South Texas Project Electric Generating Station P.O. Box 289 Wadsworth, Texas 77483

November 22, 2010
U7-C-STP-NRC-100241

South Texas Project
Units 3 and 4
Docket Nos. 52-012 and 52-013
Response to Request for Additional Information

Attached is the STP Nuclear Operating Company (STPNOC) response to Request for Additional Information (RAI) questions in RAI letter number 365 related to COLA Part 2, Tier 2, Sections 2.4S.4, "Potential Dam Failures," 2.4S.5, "Probable Maximum Surge and Seiche Flooding," and 2.4S.12, "Groundwater." This letter provides the complete response to RAI letter number 365. The attachment provides responses to the following RAI questions:

Figure 2.4S.4-13a Breach Width Development for Different n-values

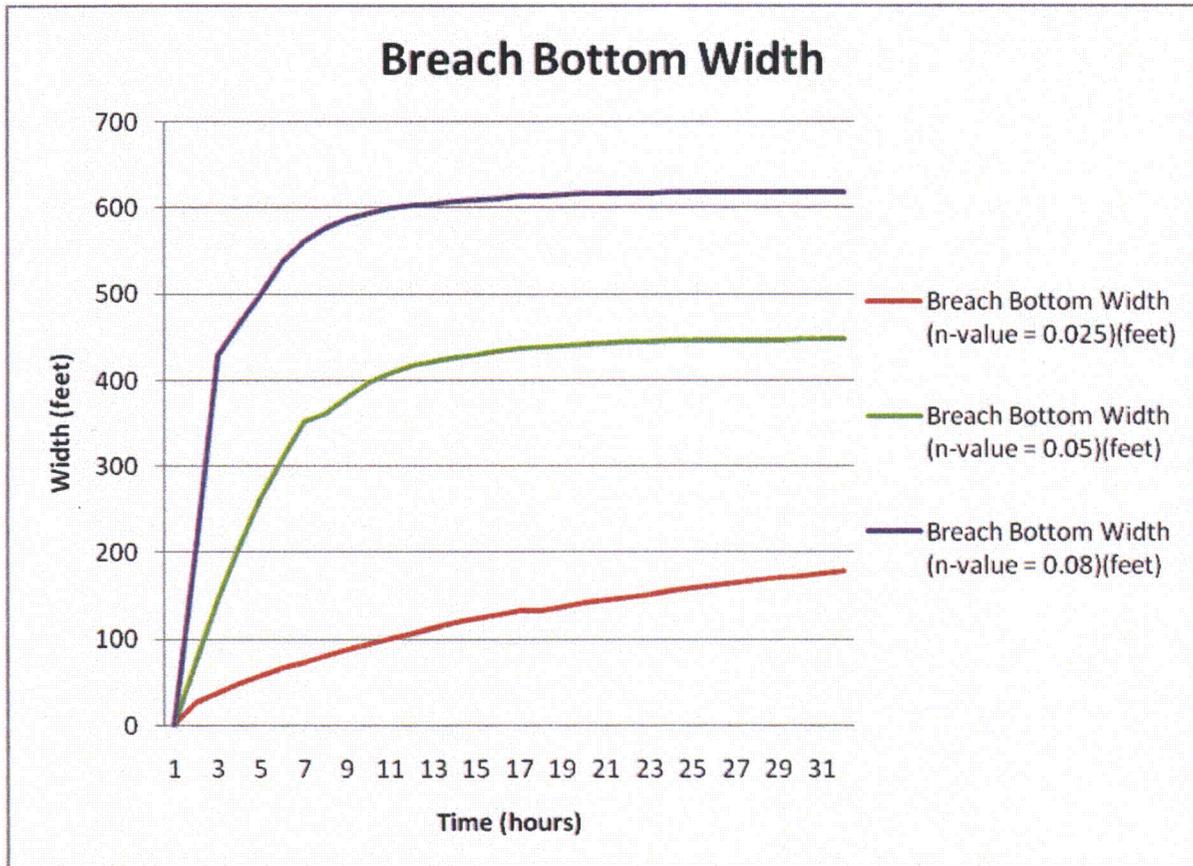
Describe the methods selected to estimate the MCR embankment breach parameters and will also describe the bases for the range of the selected breach parameters. The breach parameters shall account for the MCR storage volume and depth as well as the geometry and construction materials of the embankment.

The BREACH algorithms are such that the lowest n-value considered, 0.025, produced a lower peak discharge than the highest n-value considered, 0.05. Therefore, consideration was given to a higher n-value of 0.08 that was still considered within the range of feasibility. Table 2.4S.4-6b presents the predicted peak discharge, breach width at time of peak discharge, time to peak discharge and reservoir level at time of peak discharge for each of the three n-values modeled. Figure 2.4S.4-13(a) presents the breach width development over time for all three n-values tested. The results of the sensitivity analysis indicate that higher roughness coefficients produce higher peak discharge values, which is counterintuitive. One explanation for this may be attributed to the model predicting a sudden collapse of the pipe section of the dam sooner with the lower n-values, thus lowering the peak discharge at a critical time. It is noted that the peak discharge and breach opening rate is based on several modeling algorithms that are balancing discharge forces, sediment transport rates and structural features with predicted storage depth and tailwater depth. An n-value of 0.05 is used in the FLDWAV analysis.

Figure 2.4S.4-21j Breach Outflow and Flood Elevation to Determine Duration of Inundation at Safety-Related SSCs

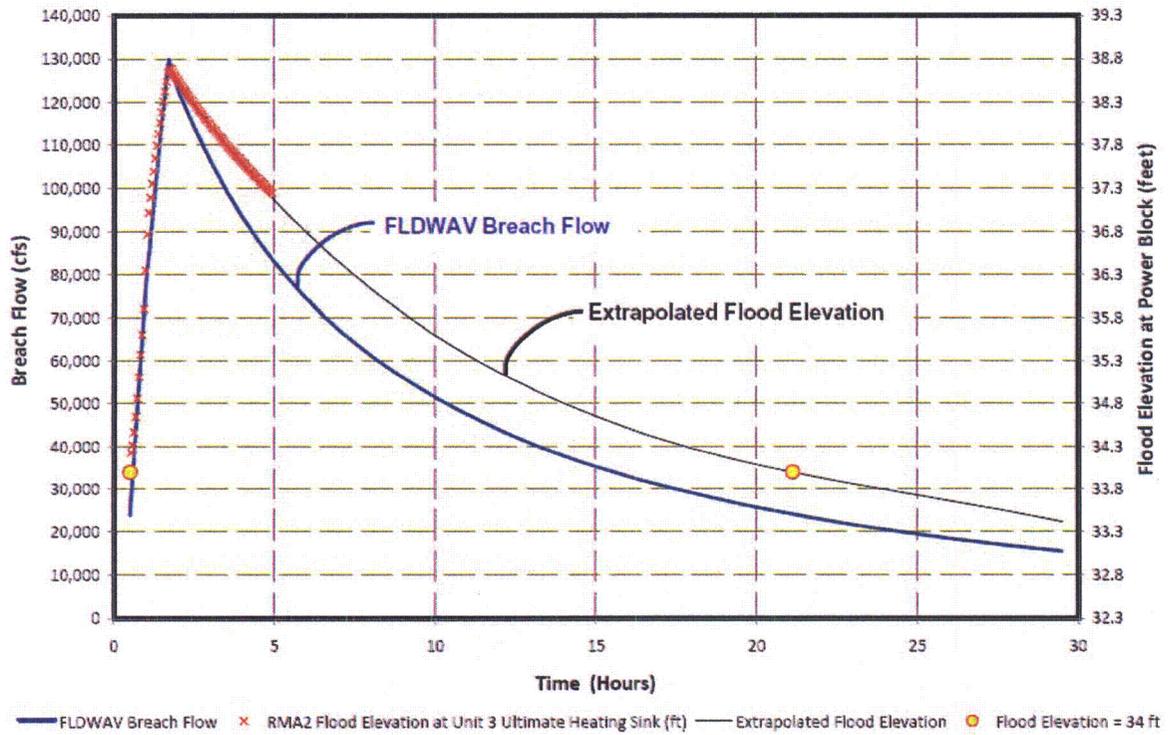
Provide FSAR updates to include: (1) a description of various methods used for estimation of MCR breach parameters, (2) description of the identification process of the most conservative breach scenario among all plausible scenarios, (3) justification why a specific scenario is chosen or why certain scenario(s) were excluded as plausible, (4) a description of the sensitivity of flood characteristics to the chosen range of breach parameters, (5) flow depth maps for the simulated flood, (6) flow velocity maps for the simulated floods, (7) peak flood discharge at safety-related structures, systems, and components (SSC), (8) duration of inundation at the safety-related SSCs, and (9) maximum estimated hydrostatic and hydrodynamic forces on the safety-related SSCs.

- (8) The duration of inundation at the power block is considered to be the duration during which the flood elevations are greater than the grade elevation of 34 feet. Subsection 2.4S.4.2.2.4.5 and Figure 2.4S.4-21(j) are added to address the duration of inundation. See FSAR markup.

Figure 2.4S.4-21f1 Sediment Accumulation (in feet) from East Breach Scenario

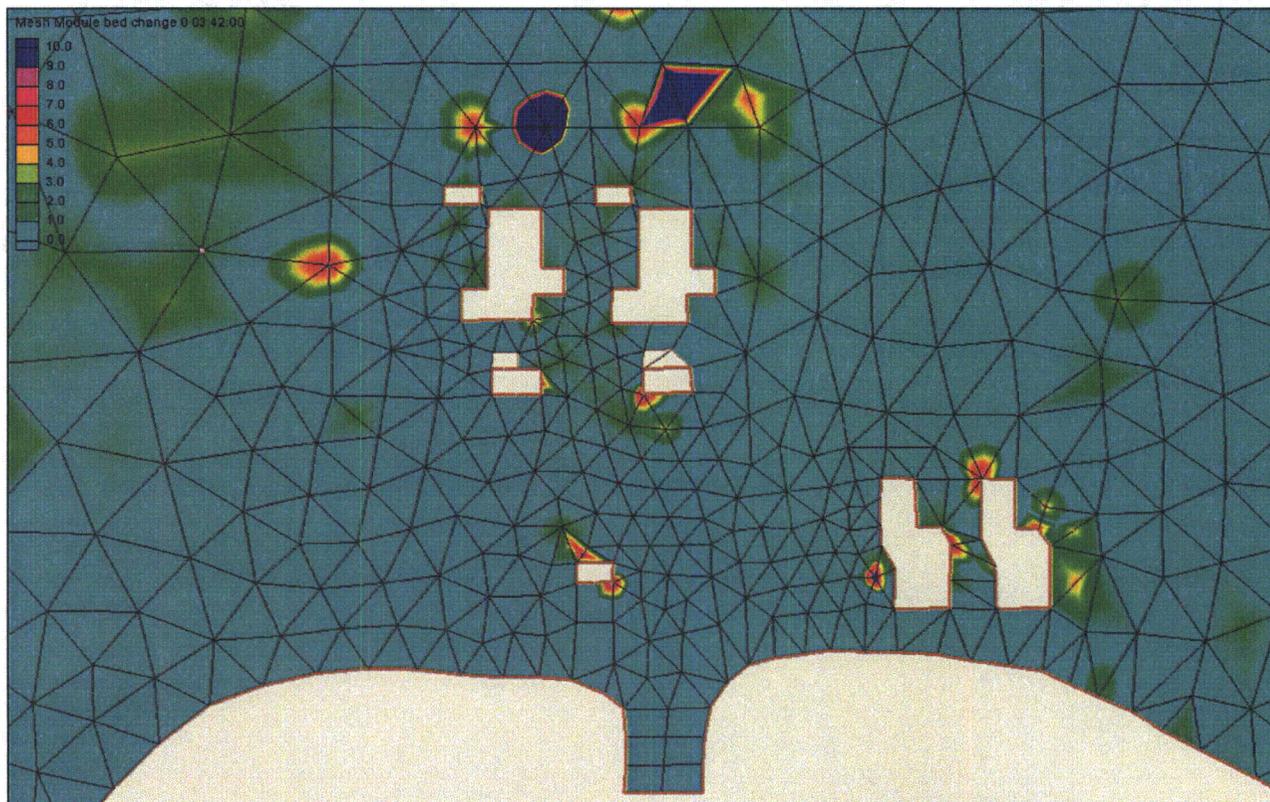
Provide FSAR updates that address the issues raised above: (1) justification for reliability and accuracy of RMA2 predictions at the STP site, (2) selection and justification of a reasonable value for the DEPLIMIT parameter, (3) a description of results of the SED2D simulation(s) that use the selected value of the DEPLIMIT parameter, (4) a qualitative and quantitative description of sediment deposition and scouring in the powerblock area, (5) a description of the physical and hydraulic integrity of the powerblock surface following the flood event, (6) a description of sediment mass balance for the SED2D simulations, (7) sediment deposition height and scouring depth maps within the powerblock area, (8) citations for precedents for the use of artificial sumps in applications of RMA2/SED2D.

- (6) Subsection 2.4S.4.2.2.4.2 is updated to include a description of sediment mass balance for the SED2D simulations. Refer to FSAR markup.
- (7) Figures 2.4S.4-21f1 and 2.4S.4-21f2 provide sediment deposition height maps. As discussed in Subsection 2.4S.4.2.2.4.2 the anticipated erosion/scouring within the powerblock area is not significant.

SED2D sediment modeling indicated some deposition on the outer edge of the model domain and relatively little deposition within the STP site. Figures 2.4S-4-21(f1) and 2.4S-4-21(f2) show the sediment accumulation pattern with accumulation at points where current velocities are relatively low for the east and west breaches, respectively. Table 2.4S-4-7b shows the amount of sediment accumulation at locations defined in Figures 2.4S-4-21(f3) and 2.4S-4-21(f4). These sediment deposition locations only involve a single 2D grid node, i.e. the node with sediment accumulation depth is surrounded by nodes with no sediment accumulation at all. This single-node result indicates isolated settling location due to very localized small velocity at the node. These results are consistent with the sediment concentration results in that the majority of the clay and sand loads would be suspended in the flood flow and washed downstream, beyond the STP site. SED2D modeling provides point elevation results that are not easy to integrate into a volume over a large area, but the small accumulation within the study area (Figures 2.4S-4-21f1 and f2) and the large accumulations noted in the sump outside of FM 521 indicated that the great majority of the sediment eroded settled in the model sump outside of FM 521. The localized single-node sediment accumulation predicted by SED2D also makes it impractical to apply the underlying 2D element area for sediment accumulation volume calculations because it will greatly over-estimate the amount of accumulated sediment volume if an artificial "pyramid" were assumed to be the sediment accumulation volume. While the user's manual of SED2D does not provide specific information about sediment mass balance in a model simulation, it states that the derivation of the SED2D model formulation is based on the basic convection - diffusion equation (Reference 2.4S-4-12j). This basic convection - diffusion equation is a mass balance equation based on the conservation of mass (Reference 2.4S-4-12k). Therefore, mass balance is embedded in the fundamental equations of SED2D and sediment mass balance is maintained by the program during the simulation.

Figure 4. Storm Surge Height (ft above MSL) vs. Distance from Site

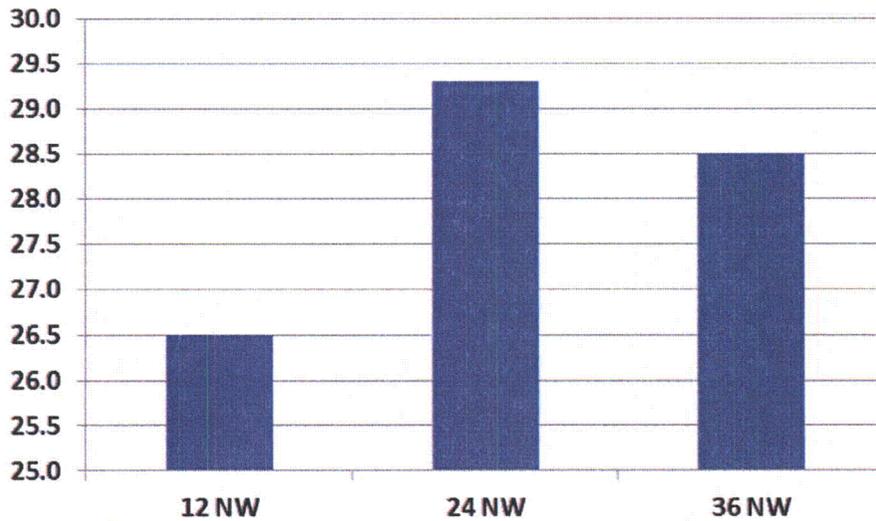
Provide the following information with applicable FSAR updates on: (1) a detailed description of the ADCIRC model including the wind-wave submodel, (2) a detailed description of supporting data sets including the topographic and bathymetric grid, (3) a list of conservatively selected plausible PMH scenarios, consistent with NWS 23 ranges of PMH parameters, used as input to ADCIRC, (4) a description and justification of why other plausible PMH scenarios were not selected as conservative, (5) a description of the sensitivity of the ADCIRC-simulated PMSS to PMH parameters, including radius to maximum winds, forward speed, track direction, and location of landfall, (6) a description of nonlinearity in estimated PMSS corresponding to various combinations of PMH parameters, and (7) the selected PMSS near the STP site including windwave runup.

Figure 4 shows the maximum storm surge at the site as a function of the shortest distance of the storm track from the site. For these three scenarios, the track direction remained constant (northwest path). As indicated in Figure 4, the greatest storm surge occurs when the shortest distance of the storm track from the site is equal to the radius to maximum winds.

Figure 10 Cross Sections of the STP MCR Embankment and a Typical Texas City Levee

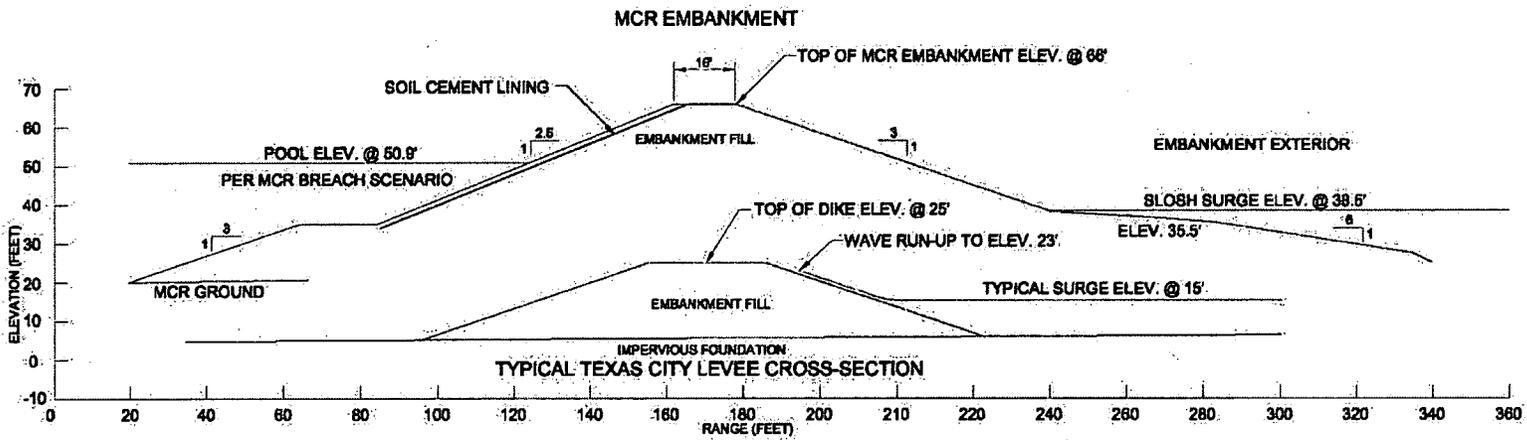
Also provide information on: (8) a detailed description of various methods used to estimate current velocities during a PMSS event, (9) a detailed description and justification of simplifying assumptions made, (10) conservatively selected current velocities and durations for which these currents will affect the MCR embankment, and (11) justification, including relevant citations, for the ability of the grass-lined outer face of the northern MCR embankment to withstand the current velocities without erosion severe enough to cause an embankment breach.

A typical cross section is shown in Figure 10. Also shown on the figure is a typical section of flood protection levee for Texas City. The Texas City levee has provided protection from hurricane surge over its life, and although that levee sustained damage during Hurricane Ike, the levee did fulfill its intended purpose of withstanding a substantial surge and wave attack over a period of many hours without a breach occurring anywhere along the 17 miles of the protective works (Reference 5). The MCR embankment is similar to, but much larger than, the hurricane surge protection levees that have, for the most part, successfully withstood major hurricane events along the US Gulf coast.

For perspective, Figure 10 also shows the typical hurricane surge level experienced by the Texas City levee and the peak surge level predicted by the 2010 version of SLOSH. There is no possibility that the STP PMSS could breach the MCR embankment. In contrast, the infamous levee failure in New Orleans during hurricane Katrina occurred due to the breach of a piling wall. This wall was constructed in dredged materials and sustained an impact force from a surge wave of significant height generated over a very short time period. The situation of New Orleans is vastly different from the MCR embankment because of the substantial size of the MCR embankment relative to that of a piling wall; the MCR foundation consists of competent clay materials relative to the failed levee location in New Orleans being founded on dredged material; and the landward side of the New Orleans levees are well below sea level.
